Discussion Paper

An instrumented screwpile load test and connected pile-group load-settlement behavior. Discussion of a paper by VanImpe, P.O., VanImpe, W.F., and Seminck, L., 2013. *Journal of Geo-Engineering Sciences*, IOS Press, 1(1) 13-36

Bengt H. Fellenius*

Fig. 1. Pile ultimate shaft resistance — Measured and as calculated by 5 CPT methods. And soil profile with CPR qc-diagram.

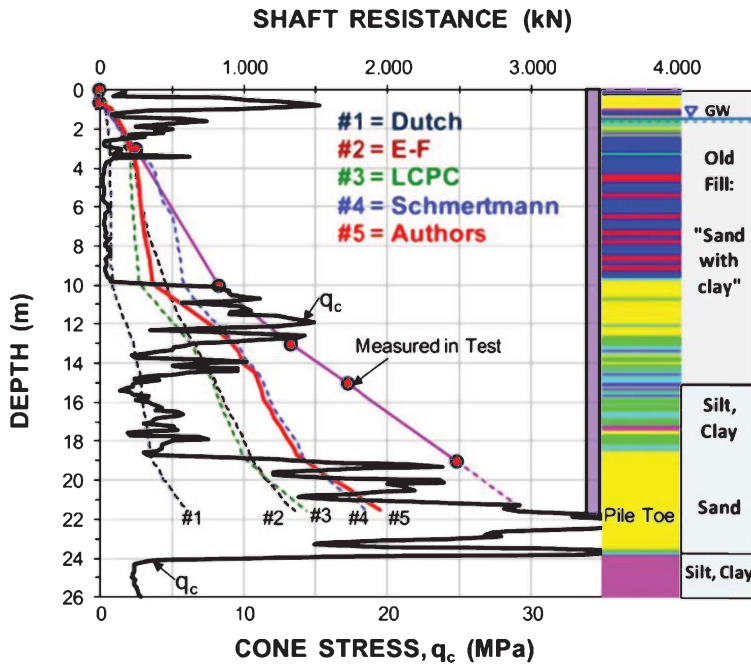
Figure 1 presents the CPT cone-stress diagram together with the authors' CPT-calculated shaft resistance distribution and the shaft resistance distributions calculated using four additional methods. The figure is supplemented with the distribution of shaft resistance measured in the static loading test at the maximum applied load and the interpreted soil profile. The CPT methods suggest that the ultimate shaft resistance of the test pile should be about 1,500 kN through about 2,000 kN.

Fig. 2. Pile toe resistance — Maximum in test and “ultimate” as calculated by five CPT methods.

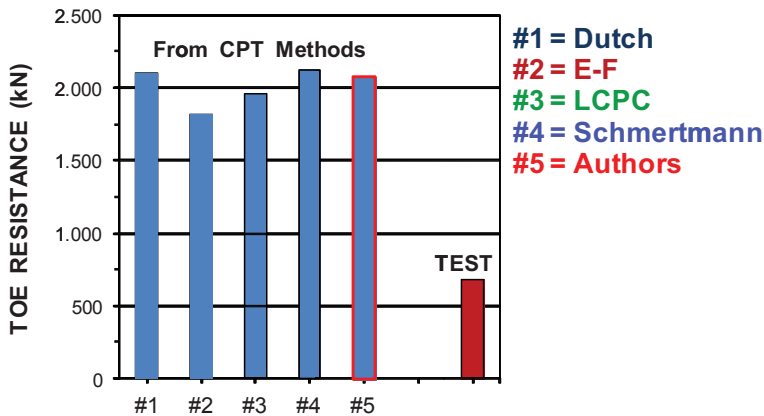
Figure 2 shows the toe resistances calculated using the same methods as determined at the maximum load applied to the pile head in the static loading test. Obviously, the CPT methods have all vastly overestimated the maximum toe resistance developed in the static loading test. The pile toe is 2.5 m, about 5 pile diameters, above the clay layer, which ordinarily should be enough to prevent a softening of the toe response due to the presence of the clay. Therefore, a question is if the depth to the clay layer varies appreciable across the site, the distance to the clay layer might be smaller at the test pile location. However, the authors' Fig. 14 indicates that the variation of the depth to

the clay is minimal at the site. They also point out that the imposition of the pile reinforcing and the instrumentation cage might have resulted in a less than perfect concreting of the pile toe.

Fig. 3. Load movement curves for head, shaft, toe, and compression.

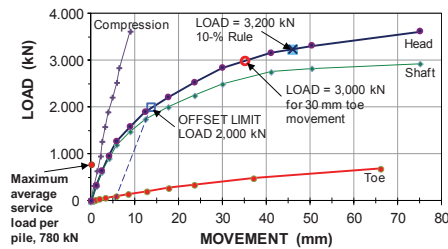
Figure 3 shows the load-movement curves measured in the static loading test for the pile head, the pile shaft, the pile toe, and the pile compression. The pile toe curve is plotted using the toe load extrapolated from the extensometer measurements. (The authors instead plotted the pile-head load versus the pile-toe movement.)

The measured shaft resistance load-movement curve does not indicate a clear value of ultimate shaft resistance. It can be estimated to range between 2,750 kN at a pile head movement of 40 mm through 2,930 kN at about 70 mm movement. Thus, the evaluation of the extensometer records indicates that the ultimate shaft resistance determined from the static test is about one-and-a-half times larger than that calculated by the CPT methods.

It is important to notice that the pile toe load-movement response is by a gently rising convex curve that does not have the slightest tendency toward a value one could reasonably define as the ultimate toe resistance. This is no surprise, it is what all properly instrumented and analyzed tests will show. Simply, ultimate toe resistance does not exist [4]. It is bewildering that the concept of ultimate toe resistance and a plastic response of the pile toe is still almost universally believed to exist—and applied to piled foundation design.

Fig. 4. Load and resistance distributions as measured and as adjusted for residual load with distribution of back-calculated beta-coefficients.

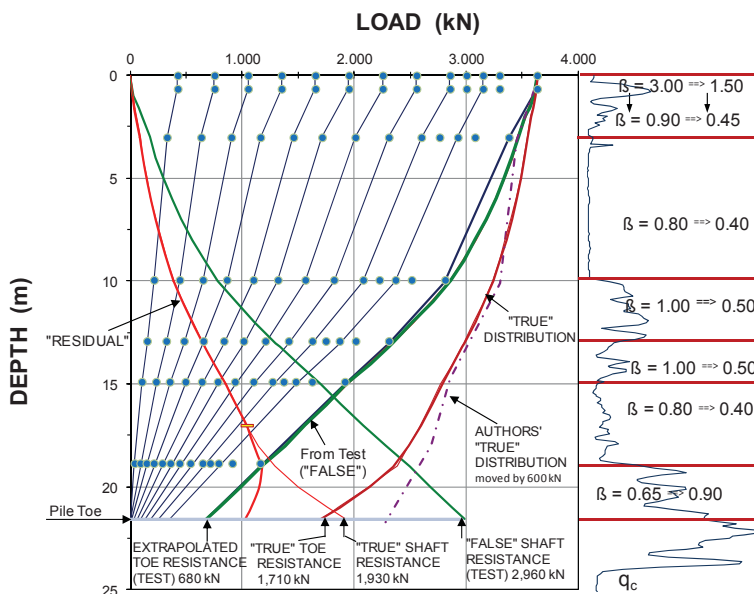
The authors suggest that the disagreement between shaft resistance calculated using the CPT-method and that found in the evaluation of the extensometer records of the test could be due to the presence of locked-in loads in the test pile, so-called residual load. They provide a load distribution corrected for residual load, which distribution is approximately equal to that produced by their CPT-method. The distribution, labeled AUTHORS’ “True” Distribution, is shown in Fig. 4 together with a more direct construction of the residual load per the principles published by Fellenius [5, 6]. The figure also includes the CPT cone stress superimposed on a column listing β -coefficients. The latter are the beta effective stress beta-coefficients back-calculated from, first, the measured load distribution (called “False”), and, then, the distribution corrected for residual load (called “True”). The three curves—the “Residual”, the “False” and the “True”—are linked, that is, any two of them determine the third. The three distributions indicate that the residual load resulted in fully mobilized negative skin friction down to about 17 m depth. Hereunder, a transition occurred toward partially mobilized positive shaft resistance.

It is not possible to tell from the records that residual load was actually present in the test pile at the start of the static loading test. It could be present and it could be as large as indicated by the authors’ “True” distribution. There is no definite indication either way. However, the β -coefficients back-calculated from the test records (the “False” distribution) are somewhat high overall and it is not logical that a β -coefficient of 0.80 would represent the shaft shear in the soft zone between the depths of 3 and 10 m. Neither is it logical that a β of 0.65 would represent the shaft shear in the very dense sand between the 10 through 22 m depth range. The coefficients back-calculated from the “True” distribution are, in contrast, logical in relation to each other and reasonable for the soil types.

The real “true” distribution probably lies somewhere in between the suggested “True” distribution shown in Fig. 4 and the distribution evaluated from the extensometer records. It is certainly disappointing that after all the effort

invested in the instrumentation, to find that the test results are unable to be more definite about the results. For example, the possibility of using shorter piles cannot be determined. Still, by simply performing an uplift test after the compression test, which would have been a relatively easy and low-cost addition to the testing programme, the issue would have been resolved. Not only would combining push and pull tests have provided the true ultimate shaft resistance (because the toe resistance would not be involved in the test), the residual load (which would have acted also on the uplift test) would have “worked the other way” and the analysis of the records from the two instrumented tests together would have determined the amount of residual load and its distribution.

Fig. 5. Observed deformations for Tanks 1 and 2 at maximum load and Tank 1 after unloading. The North direction is assumed vertical.

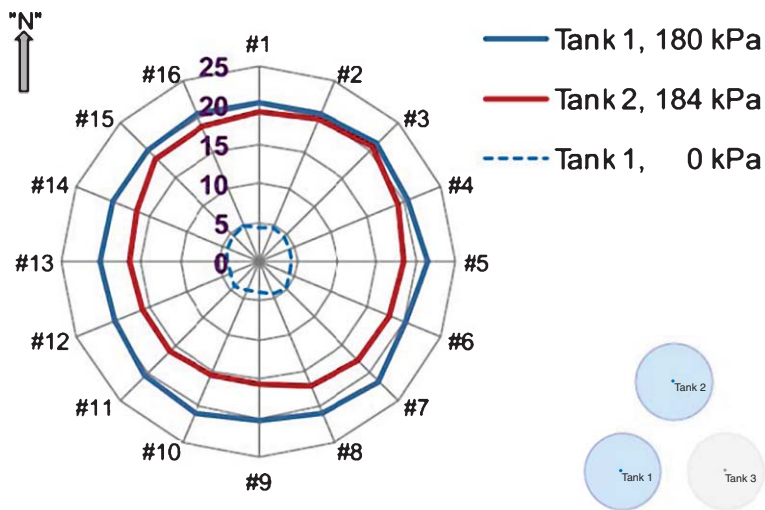
The authors mention that the interaction of unloading Tank 1 when loading Tank 2 affected Tank 2 resulted in a “tilt” of Tank 2 away from Tank 1. The term “tilt” for the differences in the observed deformation for Tank 2 is misleading, however. The tanks did not tilt. The reason for the difference in observed records is that no observations were taken of the Tank 2 perimeter benchmarks during the hydrotesting of Tank 1 (for reasons of

ongoing construction, I understand). This is clear in Fig. 5, showing a radial diagram for the maximum measured deformations along the Tanks 1 and 2 perimeters.

The measurements show that the deformations along the north-east portion of the tanks are very similar. However, in the south-west portion, the deformations on Tank 2 are affected from the outset by the fact that the stress induced from Tank 1 underneath Tank 2 was being reduced due to the fact that Tank 1 was simultaneously emptied of water. Similarly, the 0 kPa stress indicated for Tank 1 does not mean that the soil below the pile toe level is unstressed by tank load; it is stressed by the load applied to Tank 2 spreading over to the area below Tank 1. The dashed curve in the center of the diagram shows the net measured deformation for Tank 1 indicating a slight “tilt” toward Tank 2 because of the stress spreading effect. After the unloading of Tank 2 with now both tanks at zero load, had the true zero conditions then been recorded, the measurements would have shown no such “tilt”.

Fig. 6. Observed deformations for Tanks 1 and 3 at maximum load and Tank 3 after unloading. The North direction is assumed vertical.

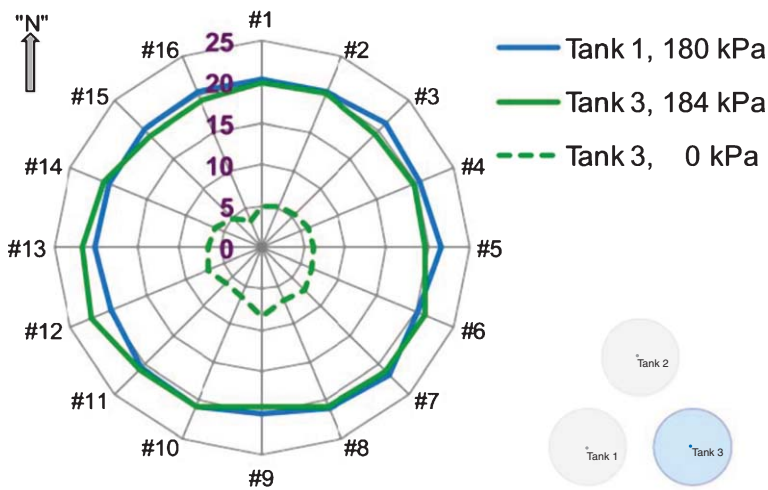
Tank 2 had been emptied before Tank 3 was hydrotested. Therefore, any influence of the stress from the hydrotesting of the adjacent tanks was gone before Tank 3 was hydrotested. Consequently, as indicated in Fig. 6, the

observed deformations for Tank 3 do not show any tendency of mutual interaction similar to the at shown in Fig. 5.

Fig. 7. Long-term settlement: immediate compression, residual compression, consolidation, settlement, and total settlement for a point at the center of the site.

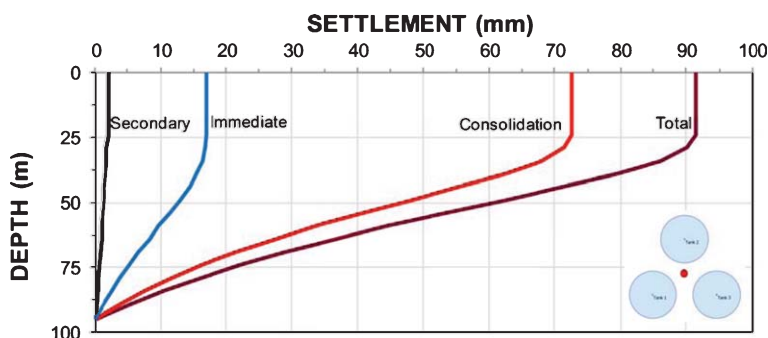
The authors estimated the consolidation settlement to be about 100 mm in the clay layer between 24 and 100 m depths for the fully loaded tanks in service. I assume they consider this to be as an average value. They did not provide the compressibility parameters for the soil that resulted in the estimated value. Of course, in the absence of proper soil parameters for the clay, one cannot do much more than produce an estimate applying best judgment. However, the best judgment estimate should be directed toward the soil parameters, not the final settlement. Once a best judgment estimate is made for the soil compressibility, the rest is simple calculations applying known soil principles and usually acceptable stress distributions. The clay is overconsolidated and I believe a reasonably conservative estimate of the re-loading compressibility is a Janbu modulus number of 80 and a stress exponent, j , of 0. (This correlates to a conventional re-loading C_{cr} -value of 0.053 for the clay, which the authors indicate to be $1,900 \text{ kg/m}^3$ and, therefore, the void ratio, e_0 , can be determined to 0.85). As the loading lies well within the preconsolidation range, the consolidation can be expected to be rapid. I have assumed that a 90-% degree of consolidation will be attained in 3 years.

Figure 7 shows the long-term settlements versus depth below the center of the site: the immediate compression, residual compression, consolidation, settlement, and total settlement, as based on the mentioned soil compressibility (modulus number) and site specifics.

Fig. 8. Settlement versus time (years) as calculated for the Site Center and Tank 1 Point #5.

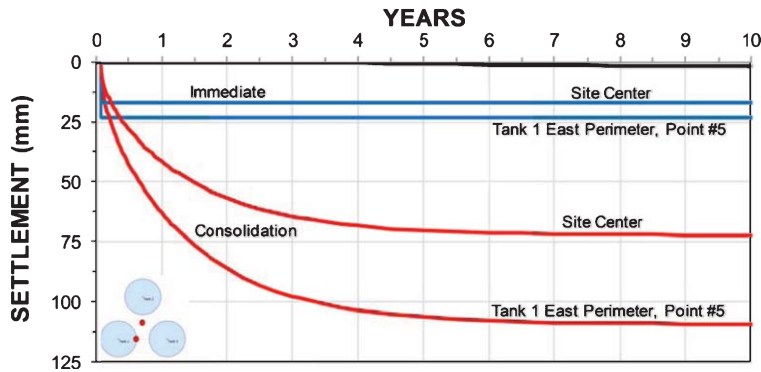
Figure 8 shows the development over time of the settlements for two points: the Site Center and Point #5 on the perimeter of Tank 1. Based on the assumed time for attaining 90-% degree of consolidation, only a marginal amount of settlement will develop after about 5 years. Of course, filling and emptying the tanks will result in ‘elastic’ compression and rebound, more or less immediate, of the piles and the soil.

Fig. 9. Settlement distributions below Tank 1 center line.

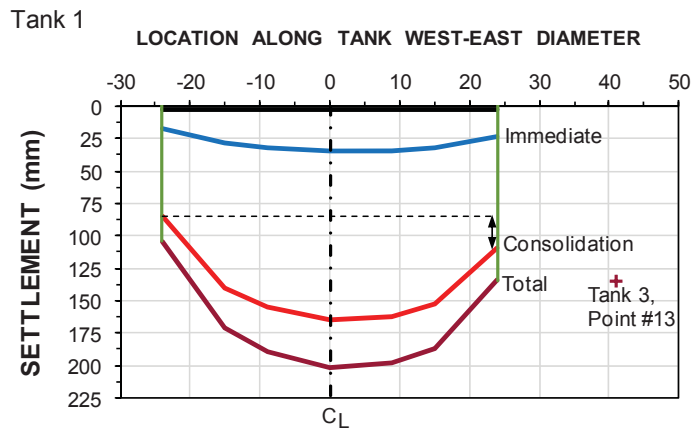
The calculations provide two important results: first, in the long-term the tanks will experience a small tilt due to the interaction of the loading, and second, the center of the tanks will settle considerably more than the perimeter. Figure 9 shows the calculated settlements for a diameter west to east of Tank 1 indicating that the tilt will be about 30 mm across the 65 m distance, i.e., about $1/20,000$, which is close to the authors estimated value of $1/12,000$. The settlement difference between the center of the tank and the perimeter will be about 100 mm, which might be of some concern for the tank base, should the predicted deformation actually develop.

The estimated—predicted—long-term deformations depend primarily on the relevance of the assumed compressibility of the clay, the modulus number of 80. I intended for this to be a realistic value, but one on the cautious side. The assumption of flexible foundation is conservative for the settlement difference between the tank center and perimeter; but not overly so. Regardless of the actual magnitude of the settlements, I expect that the center of the tanks will settle about twice as much as the perimeter.
